Service Bulletin

BULLETIN # 254

MC105, WELDARC 200I AC/DC

CHECKING PRIMARY CABLE CLEARANCE

Inspection with Cover Plate Removed

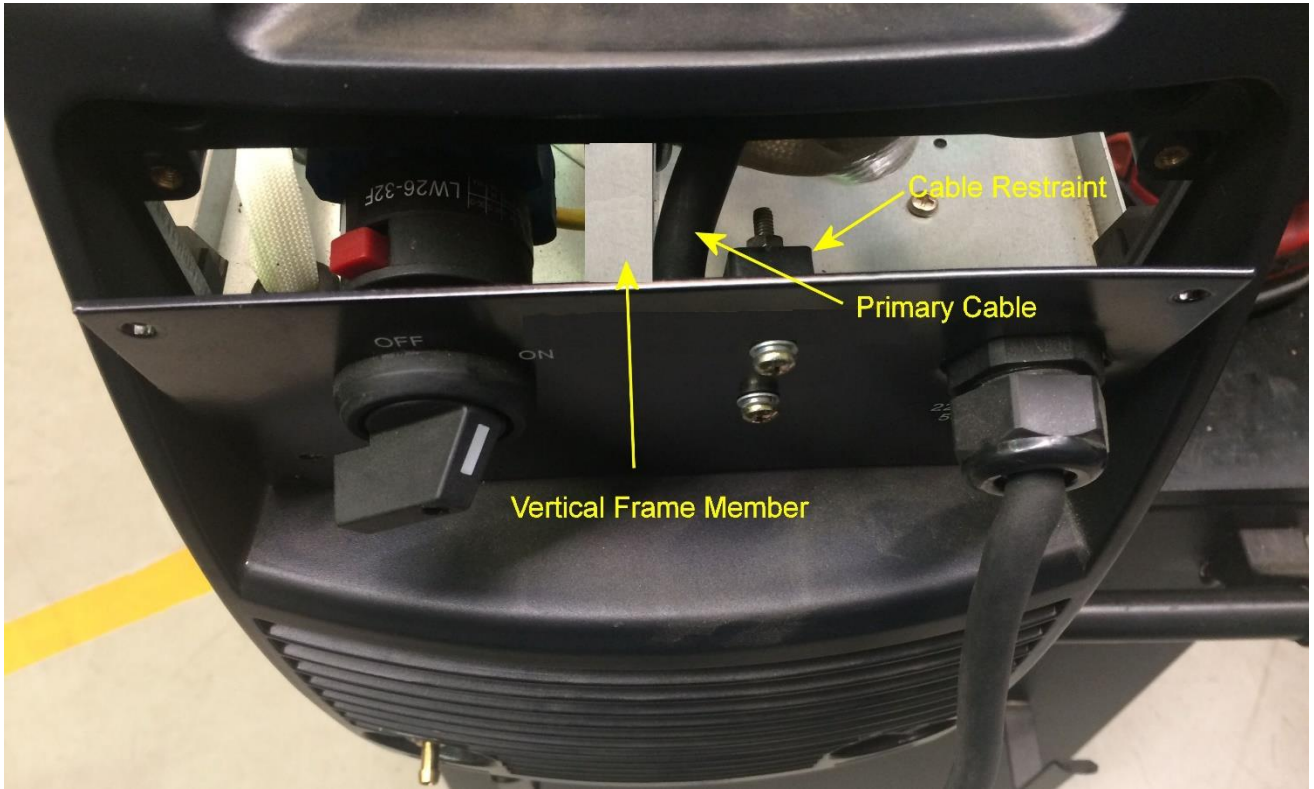
There has been a small number of instances where the one wire of the primary cable has become squashed between the rear panel and the vertical metal frame member. This has resulted in the insulation being damaged and the wire has contacted the machine frame.

Remove 6 x screws from the cover plate on the rear panel as per photo. Normally removing this cover plate is sufficient to carry out the inspection, however it is expected that removal of the complete machine cover will be required if any remedial work is required.

The outer insulation sheath of the primary cable must extend through the cable restraint such that the sheathing protects the primary wiring as it makes a sharp 90 degree bend to run along side the vertical frame member.

If it doesn't extend far enough, loosen the cable restraints and cable gland and extend a sufficient length of the sheathed portion through.

The excess active and neutral wire length must then be prevented from being trapped between the frame member and rear panel. This can be achieved by either of 2 methods:

1. Shorten the 2 cables, and attach new forked lugs, or
2. Pull excess length towards the switch and restrain the cables with cable ties so that any excess length is prevented from coming back through the hole in the vertical frame member.

Correct Installation of Primary Cable

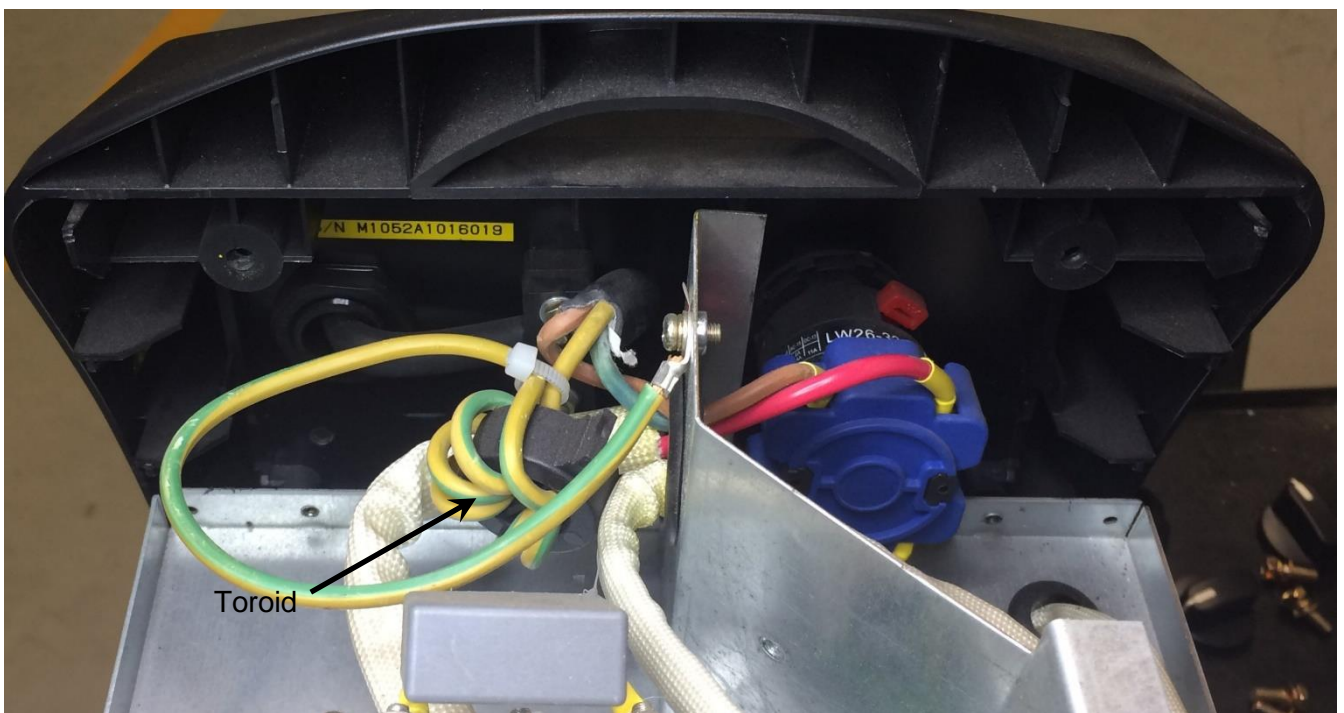
If the sheathed portion is correct as described above and does not require modification, then check that the active and neutral wires are only just long enough to reach the on/off switch without excess length. If either of these is too long there is a chance that it may become squashed between the rear panel and the vertical frame member. To rectify this either:

1. Shorten the 2 cables, and attach new forked lugs, or
2. Pull excess length towards the switch and restrain the cables with cable ties so that any excess length is prevented from coming back through the hole in the vertical frame member.

Check that the earth wire and toroid are tethered so that they are secure and unable to contact electrically live parts. Tie with cable ties as necessary to achieve this.
